October 11, 1982

Subject: Potential Substantial Safety Hazard Report

Subject: Conval Forged Valve - Report of Potential Galling of Stem to Bonnet

# CLAMPSEAL VALVE - THREADED GLAND

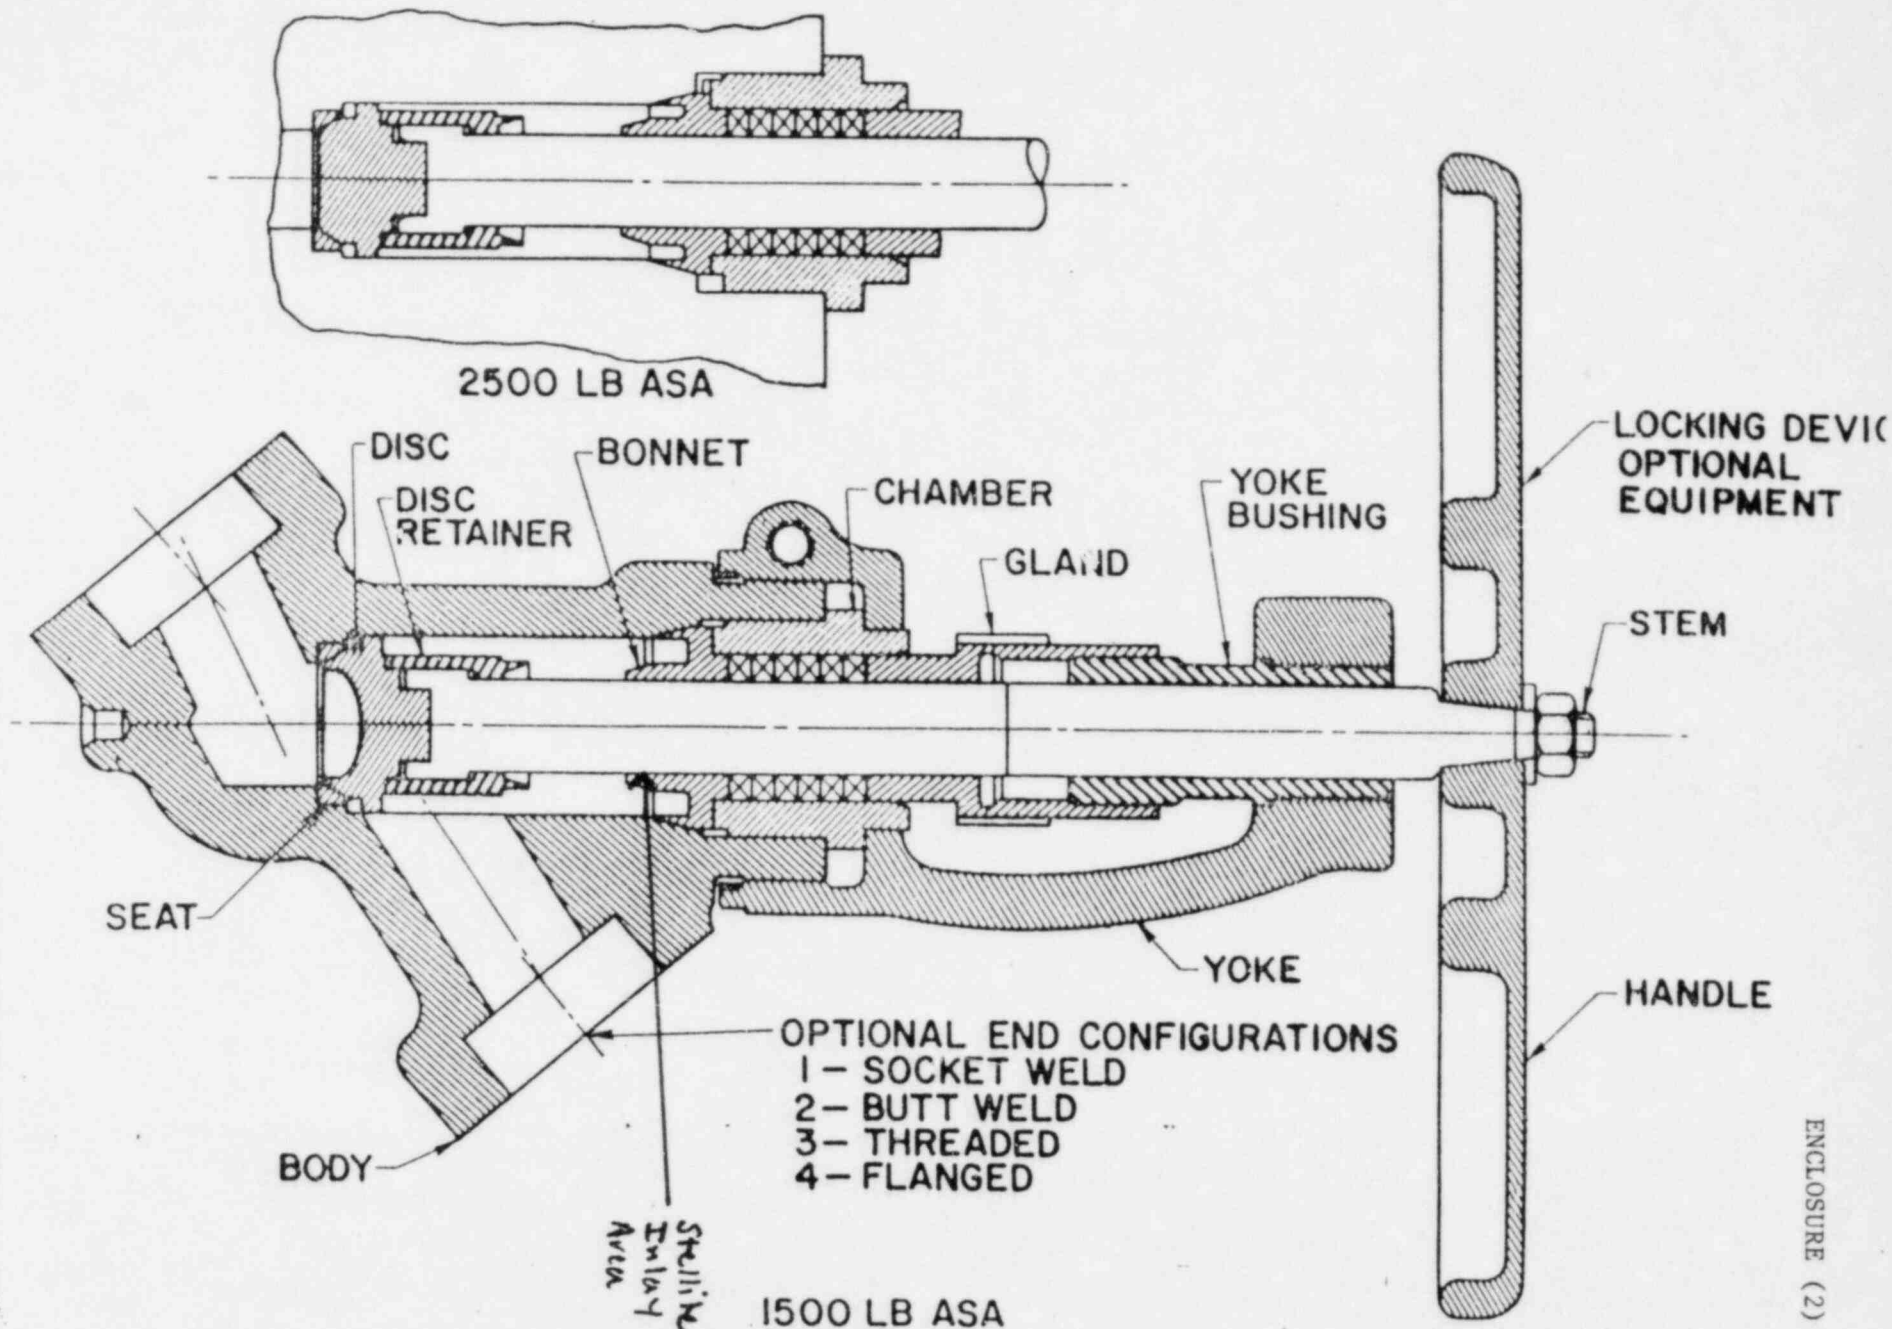
Conval has received reports and some parts returned from the field which alerted us to a galling problem. There have been no reports from nuclear plants. The most severe cases were observed to occur in fossil stations with steam temperatures above 600°F and pressures in the 2500 to 3500 psi range. The drawing, enclosure (2) illustrates the area of interest. We have determined that with a stellite guide area on the bonnet and a chrome plated stem, galling will not initiate even with considerable side thrust.

Conval has determined that in certain of our valves supplied with stem material of ASTM A582 416 stainless steel and bonnet material of Nitronic 60 (UNS S 21800), a galling action is possible between the stem and bonnet which could substantially increase operating torque and ultimately result in inability to operate the valve.

This combination of materials was supplied in our A105 carbon steel and A182-F22 valves of sizes 1 1/4" and larger during the period of February 1981 to August 1982. Prior to that period, our standard bonnet materials were Stellite 21 or Haynes 716 alloy which were not prone to galling. In late August 1982, Conval instituted design changes to both bonnet and stem to provide a Stellite 6 overlay on the bonnet guide area and a hard chrome plating on the stem. Our testing has shown that this combination of materials is not subject to galling.

The onset of galling requires repeated operation of the valve and is most likely to occur at higher temperatures and where significant side thrust is experienced on the stem. For this reason, we recommend that those safety-related valves which contain the 416/Nitronic 60 materials be serviced at the earliest opportunity, and that the stem and/or the bonnet be replaced with one of new design. Replacement of either part will eliminate the susceptibility for galling.
